Ms Prity Cleary
Senior Planning Officer
NSW Department of Planning, Housing and Infrastructure
Objection submitted via NSW Major Projects Portal

7 October 2025

RE: SSDSSD-83431958 Residential development with infill affordable housing- 16-20 Middle Harbour Road, Lindfield – 98 Apartments including 19 Affordable units

Source: Martens Flood Report

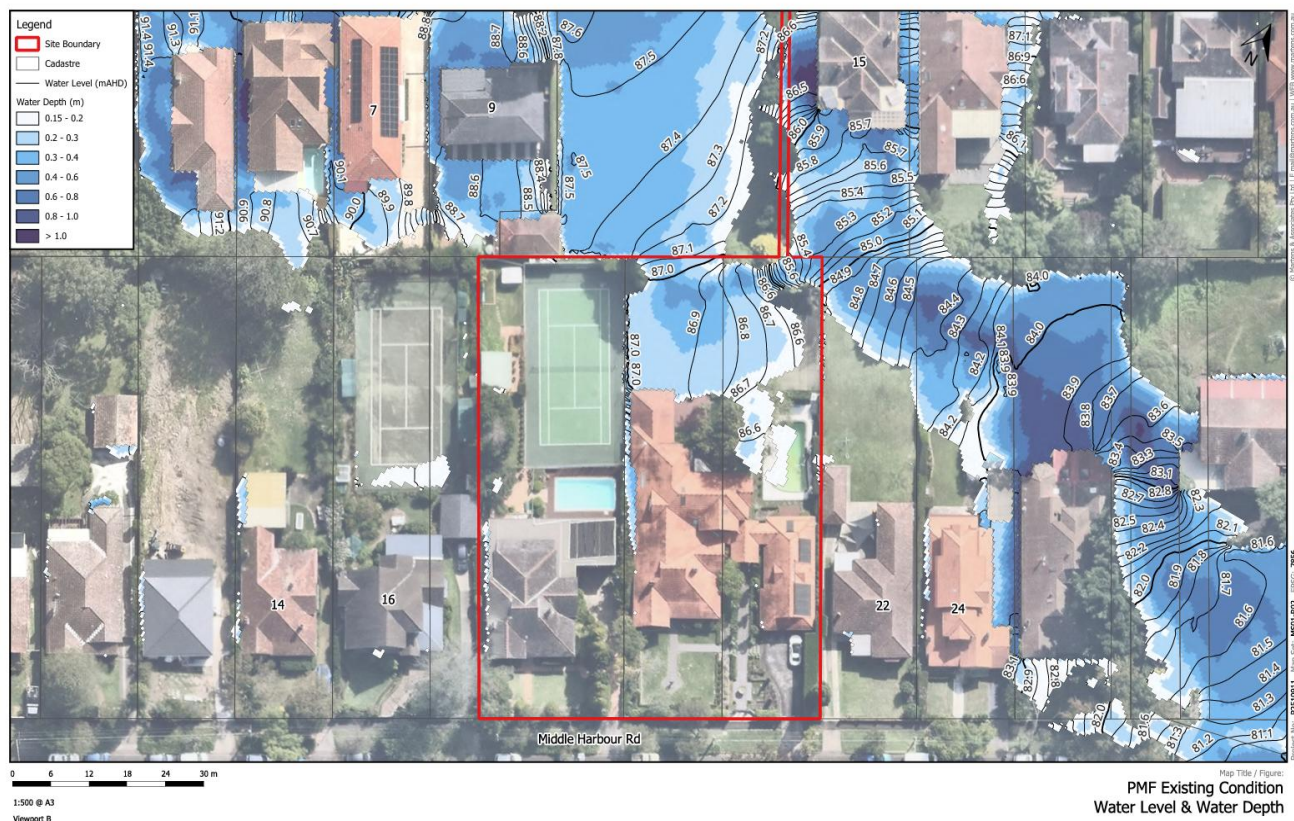
The Ku-ring-gai Council supplied flood certificate for 18 Middle Harbour Road states that the minimum habitable floor level is confirmed as 85.64 -87.53AHD (Australian Height Datum). This is higher than the proposed lower ground floor apartments at 86AHD.

The Martens Flood Assessment

- The site is identified as being affected by an overland flow path in the north-eastern corner of No. 18-20 Middle Harbour Road.
- Based on the modelling results under existing conditions, floodwaters overtop Russell Avenue and flow across 22 Middle Harbour Road, entering the site along its northern boundary.
- The flows then continue along the drainage depression at the rear of the site in a north easterly direction, ultimately discharging onto 22 Middle Harbour Road.
- The Martens Report states 'The existing conditions at the site were found to show areas of high, medium, and low flood hazard on the site. The site experiences significant inundation during the 1% AEP and PMF events.'

Figure 17: Detail, heritage map showing heritage items and Conservation Areas in relation to the subject site. The site is outlined in black and shaded dark blue.

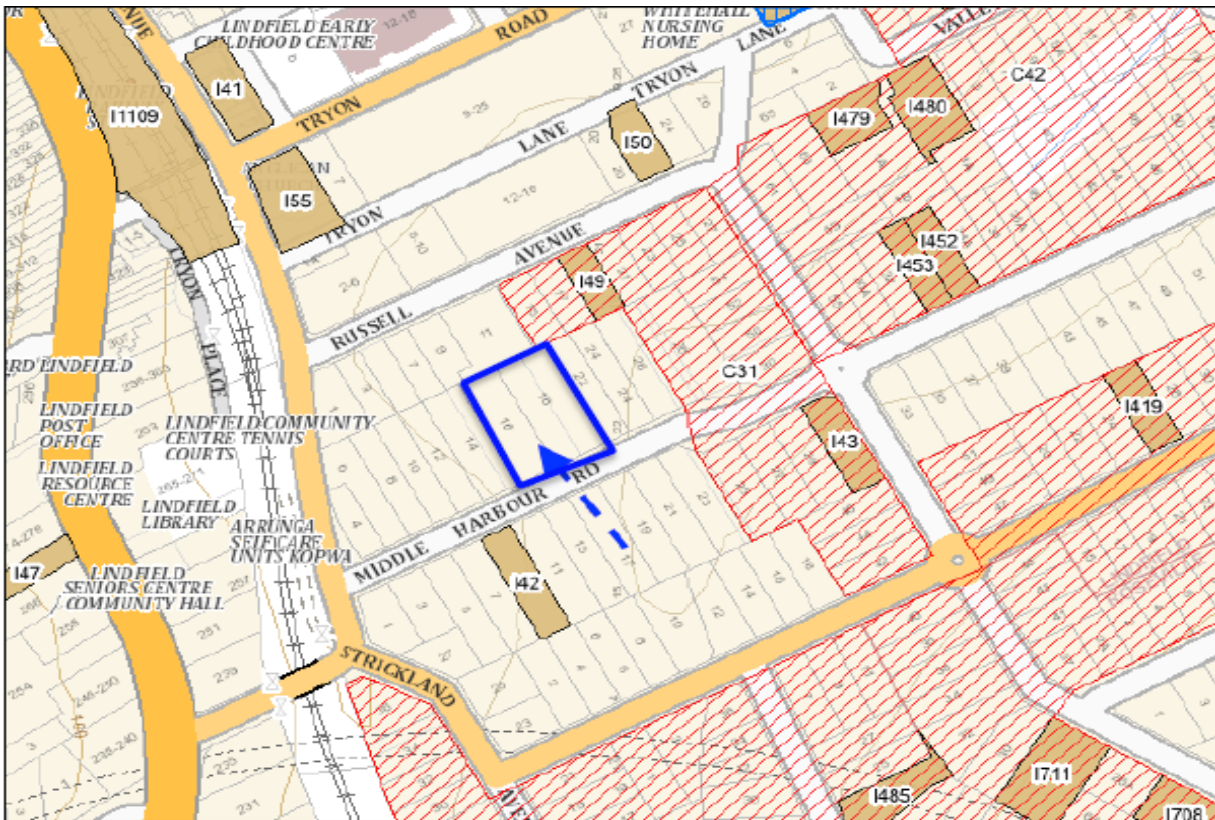
The Heritage report also states that due to the height of the development, it will be visible from the Clanville Avenue HCA as well as the Heritage item at 34 Middle Harbour Road.

It is understated in the HIA report paid for by the proponent, but it is clear that this development will have a major detrimental impact on the heritage of the area, its heritage items and the integrity of the HCAs and should be rejected.
